California Wind Energy Association

Re: Renewable Energy Executive Order - Docket No. 09-Renew EO-01
Revised Mitigation Target Area Map for Interim Mitigation Strategy

DRECP Proposed Mitigation Areas in Relation to 80-meter Wind Resource

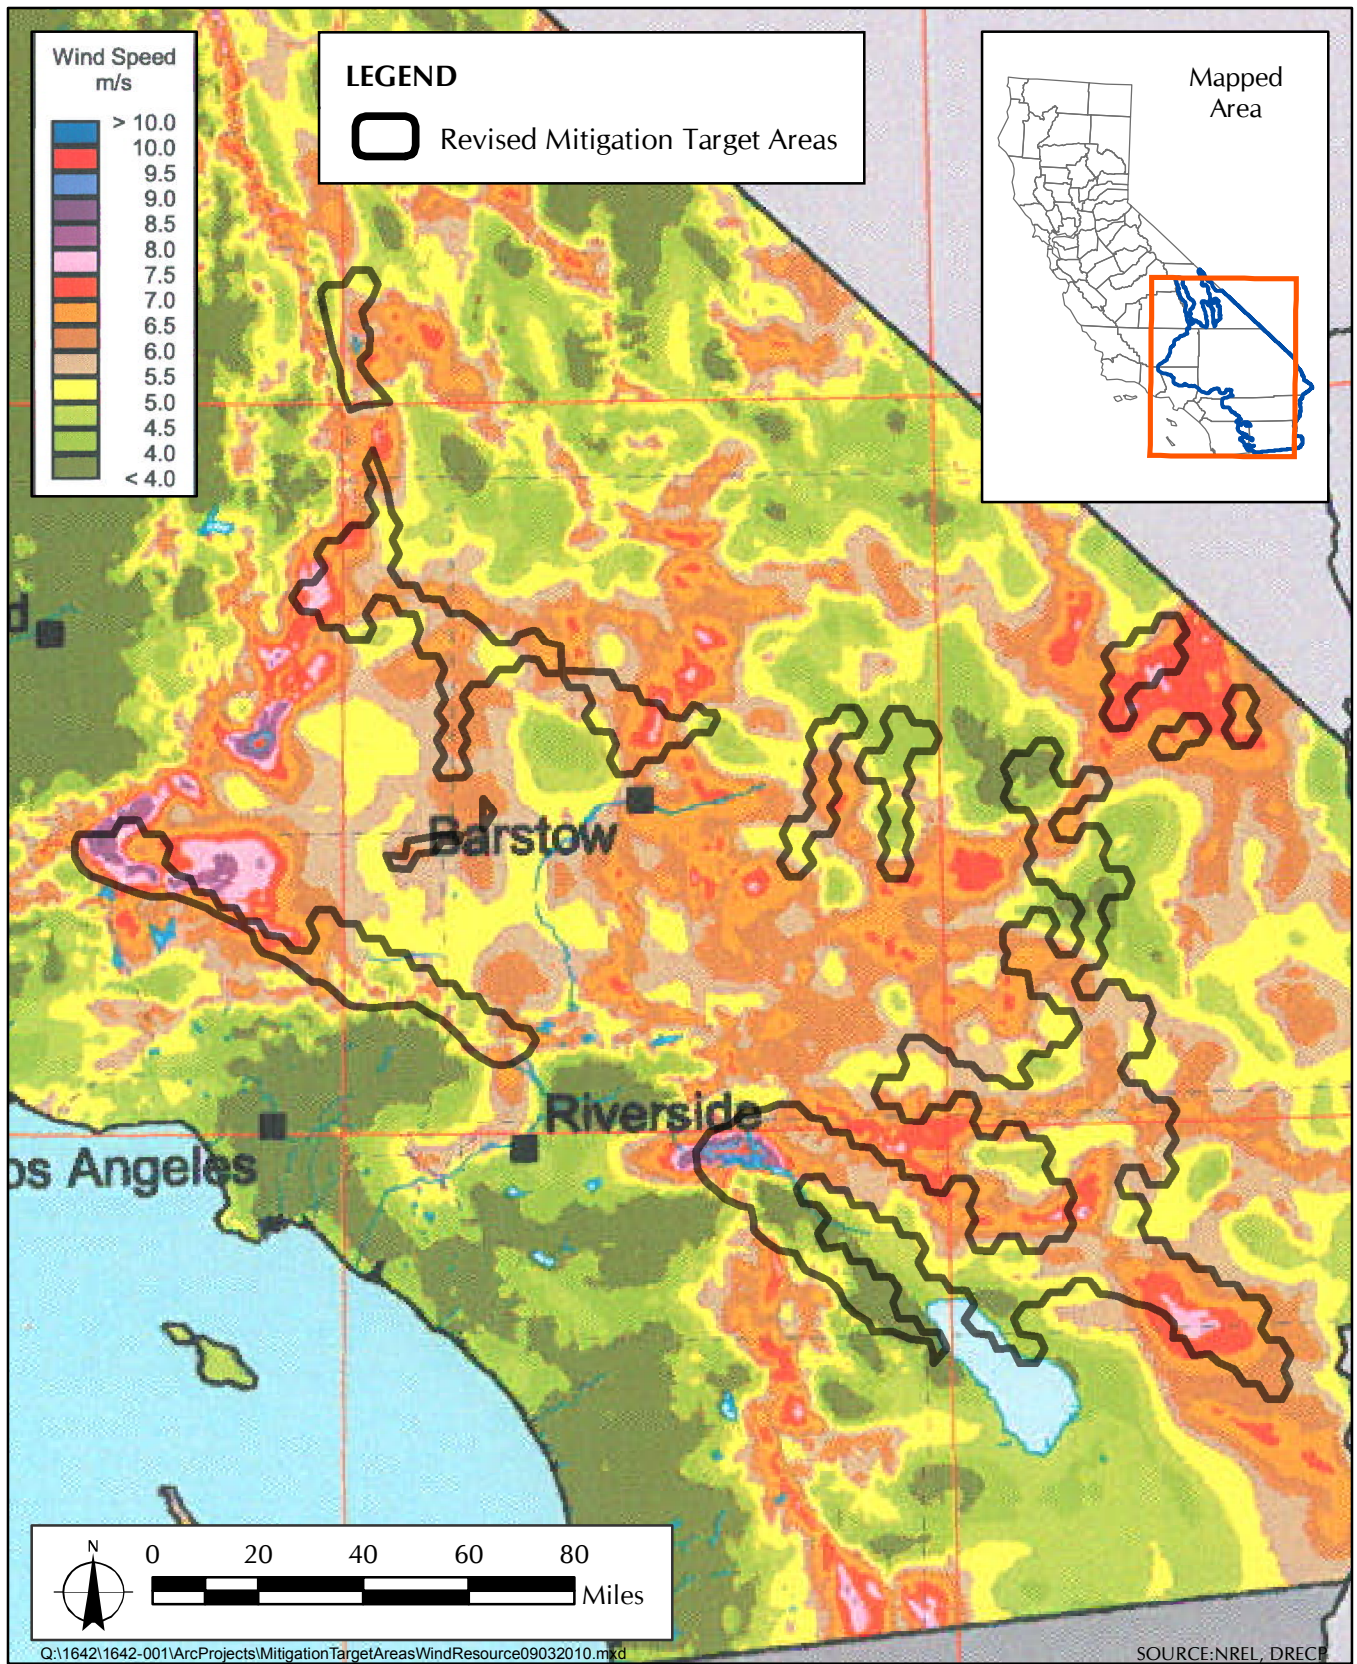
In general, we urge the DFG to use a wind resource map overlay in its planning efforts so that all existing wind power projects and undeveloped wind resources of Class 5 and higher (measured at 80 meters above ground) are avoided entirely at this early stage in the DRECP process. (See wind overlay map, attached.) Specifically, CalWEA is concerned about two areas of active commercial development – the San Geronio Pass / Palm Springs area and Highway 40 South of Ludlow -- that are identified as MTA areas and we respectfully request that the DFG remove these areas from the MTAs.

San Geronio Pass / Palm Springs – Many existing wind power projects and infill wind project sites in this historical development area are designated as MTAs. While existing wind project areas are not appropriate for acquisition for conservation purposes for obvious reasons, vacant areas surrounded by operating wind projects (“infill sites”) are logical areas for development that should be encouraged. Indeed, the Independent Science Advisors report acknowledges and appears to accept the likely clustering of renewable energy developments. Further, many of the sites in this wind resource area are

Highway 40 South of Ludlow -- The lands south of Interstate Highway 40 near the Town of Ludlow contain substantial wind energy resources under active development. Inclusion of these lands within an MTA would be contrary to the DRECP's goal of encouraging renewable energy development in previously disturbed areas neighboring established transmission routes. This area is traversed by a designated transmission corridor, and is heavily disturbed by the Town of Ludlow, a railroad and rail yard, U.S. Route 66, a mine access road, and various other disturbances associated with more than 110 years of local industrial, commercial and residential activities.

Of particular concern to CalWEA is the inclusion of Section 7 of Township 7 North, Range 8 East within a proposed MTA. Section 7 includes prior railroad and access road disturbance, a designated transmission corridor under Section 368 of the Energy Policy Act of 2005, and is subject to approved Bureau of Land Management wind energy right-of-way number CACA 48677, which the BLM issued to one of CalWEA's members. In addition to its wind resource value, Section 7 provides critical road and transmission line access points for right-of-way number CACA 48677 because of its proximity to the Town of Ludlow, Interstate Highway 40 and the designated transmission corridor. By obtaining a wind energy right-of-way over previously disturbed lands in close proximity to developed lands, highways and an existing transmission corridor, our member has come as close to meeting the "no regrets" recommendations of the DRECP Independent Science Advisors as one could hope. Relegating it to MTA status would frustrate the goals and purposes of the DRECP.

In short, an MTA designation for BLM right-of-way CACA 48677 and all other lands south of Interstate Highway 40 near the Town of Ludlow (which also have high wind energy potential) would obviate the DRECP's goal of encouraging renewable energy development in previously disturbed areas neighboring established transmission routes.

Again, we respectfully request that all existing wind energy projects and undeveloped wind resource areas of Class 5 and higher (measured at 80 meters above ground) be avoided entirely in any MTA, particularly the two areas of active commercial development described above.
